MEETING:	REGULAR MEETING OF THE PLAN COMMISSION
DATE AND TIME:	Monday, August 14, 2023 6:30 PM
LOCATION:	Germantown Village Hall Board Room N112 W17001 Mequon Road

PLANNED DEVELOPMENT DISTRICT (PDD) & CERTIFIED SURVEY MAP (CSM) APPLICATIONS

Village Planner Report

Hans Dawson, agent for Moraine Development LLC, property owner, is requesting approval of a rezoning application to create a Planned Development District (PDD) and Certified Survey Map (CSM) for purposes of restoring and redeveloping the former gravel mining site into a 126-acre residential conservation development located at W218 W11546 Appleton Avenue.

SHEET NO:
C1.04

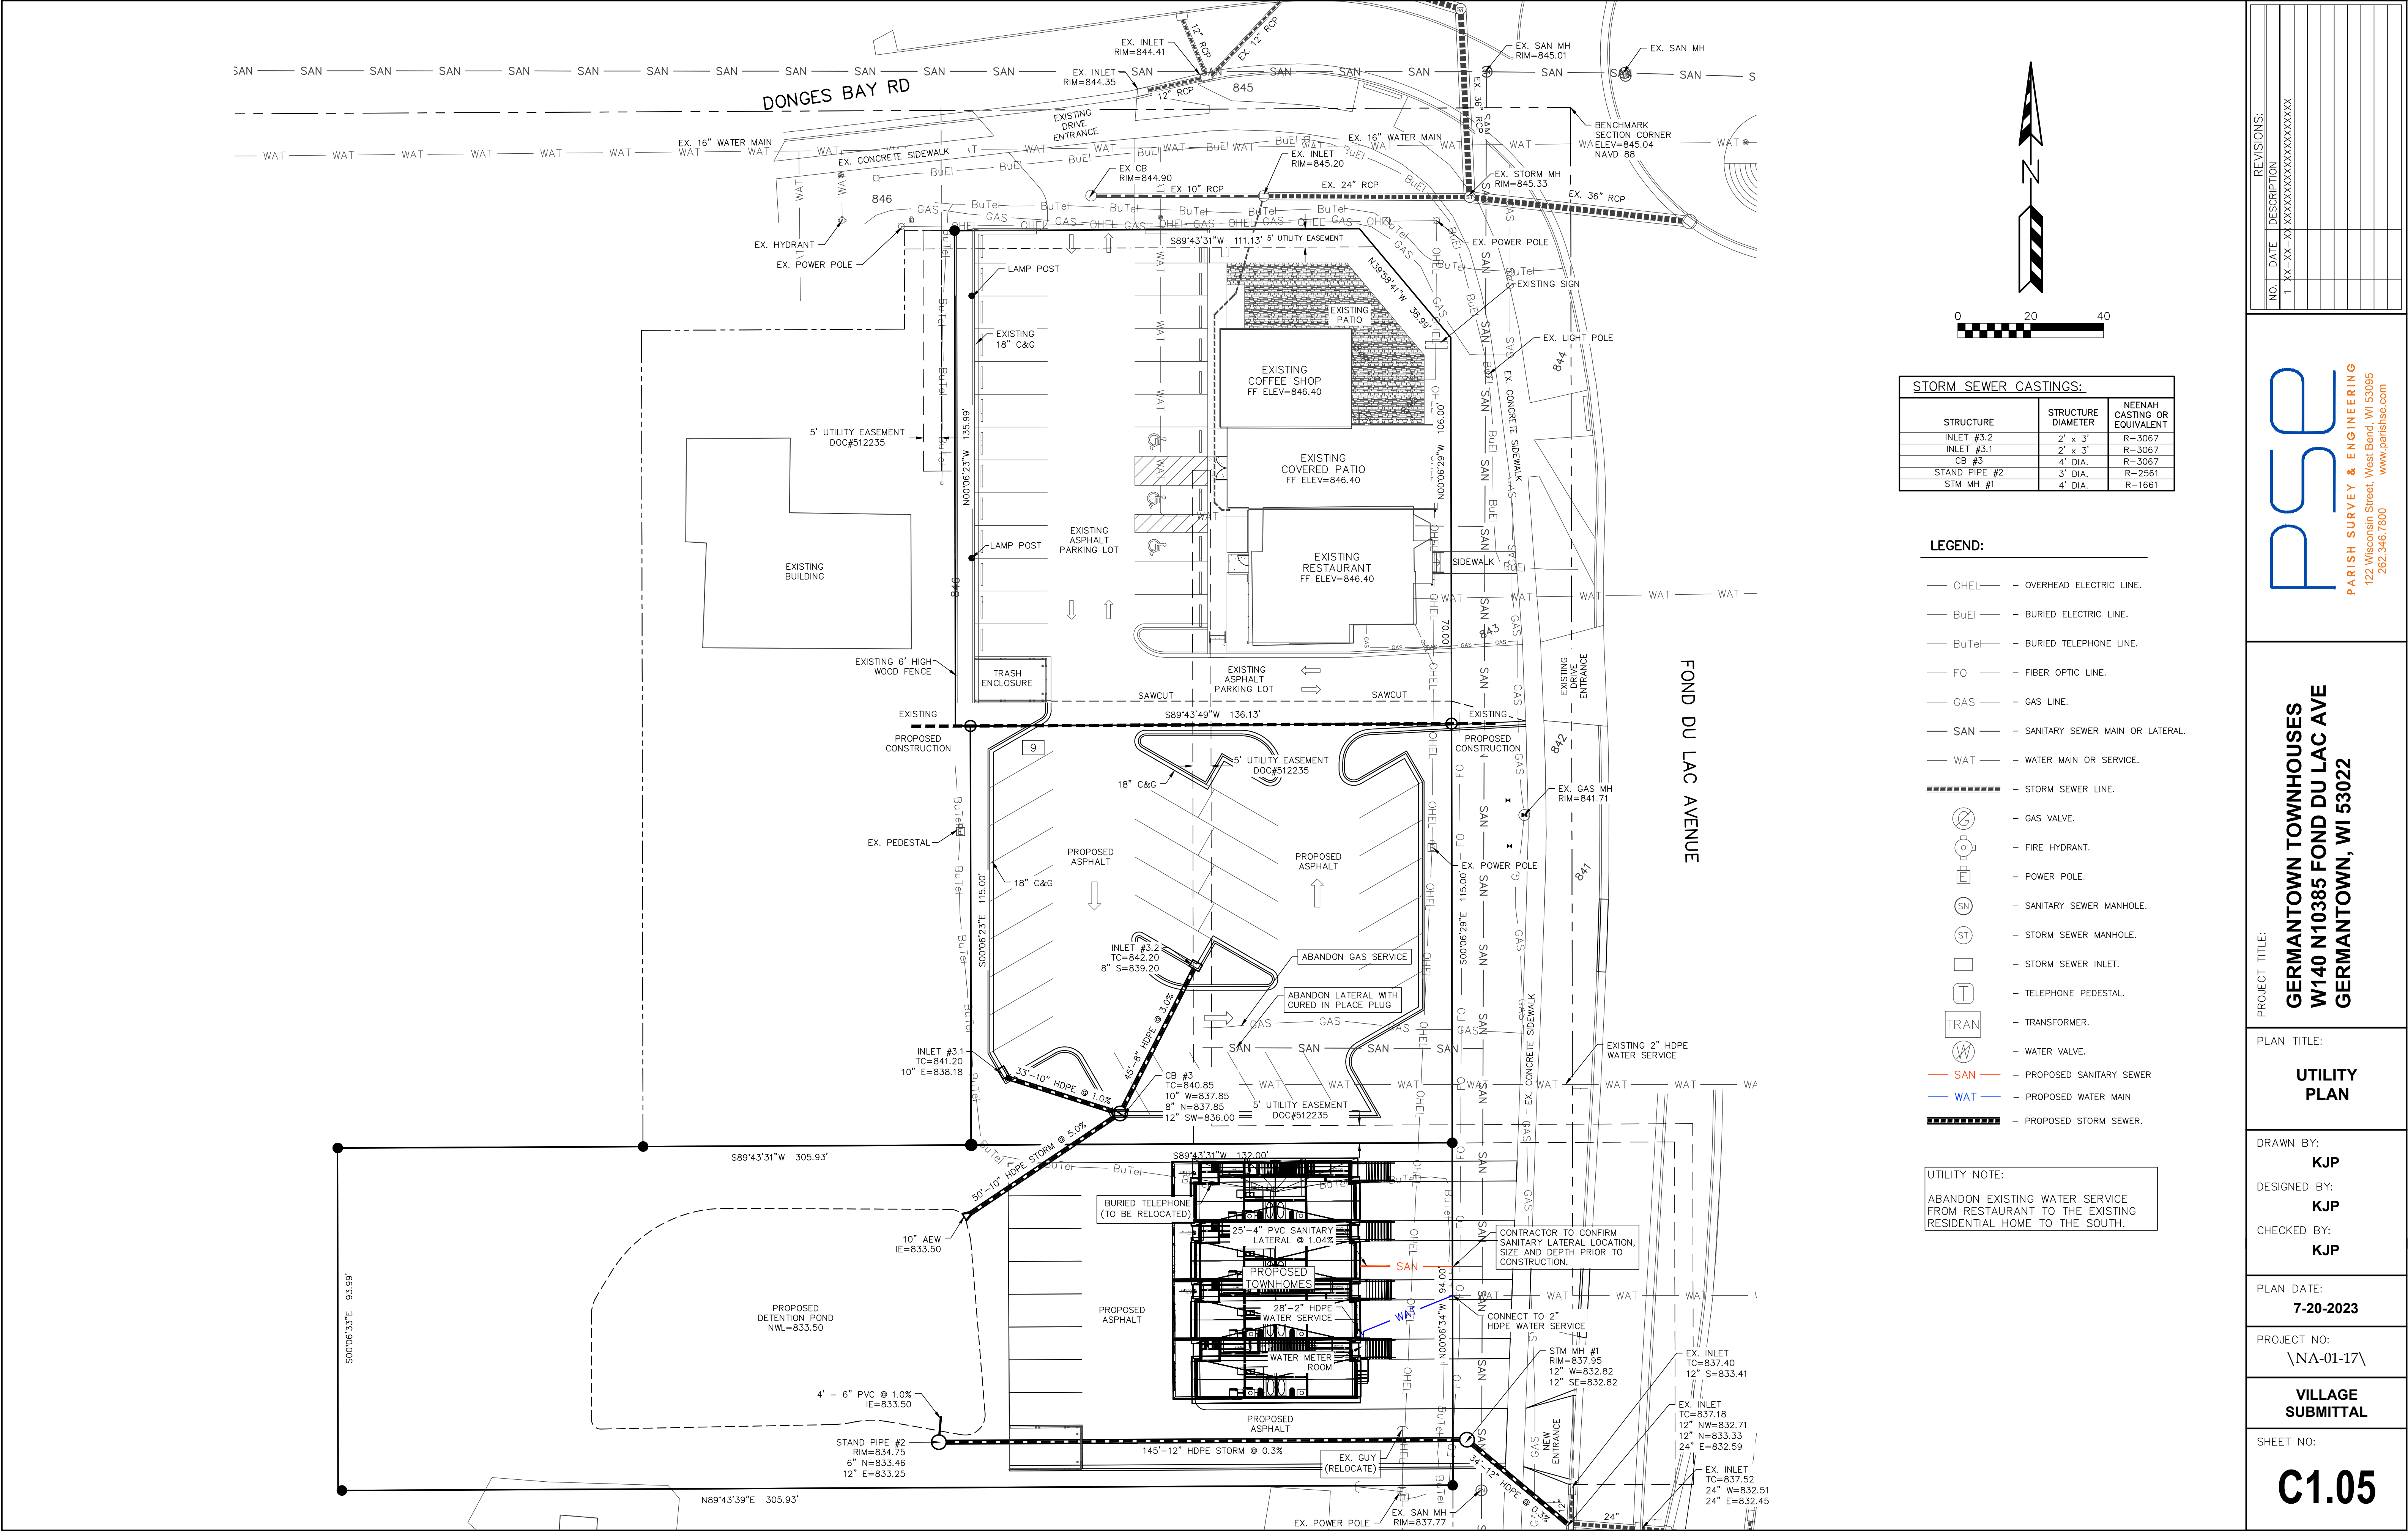
1. #4-sheet Virtus Development No. C1.05 "Utility plan" there is no 2" lateral to the Ranch house to be Razed, south of the Bar. The feed for this Ranch house is from the next north property which service comes from the center of the three buildings in a row. This lateral will be properly capped and abandoned inside the basement of the Bar. Abandonment inspection by Safe Bulit.
2. The new lot, the site of the 4 family calls out an existing 2 in HDPE water lateral to connect to. This does not exist, There is no water lateral to this site. A new water lateral will be required tapped from the main located on the east side of 145.
3. If there is to be a sprinkler meter installed it is required to be connected prior to all the meters for each livable unit.

1. Sheet C1.05 – Lateral to be abandoned at the main with a cured in place plug. Owner to verify integrity of existing lateral at vacant lot and provide village with documentation of condition before reuse.
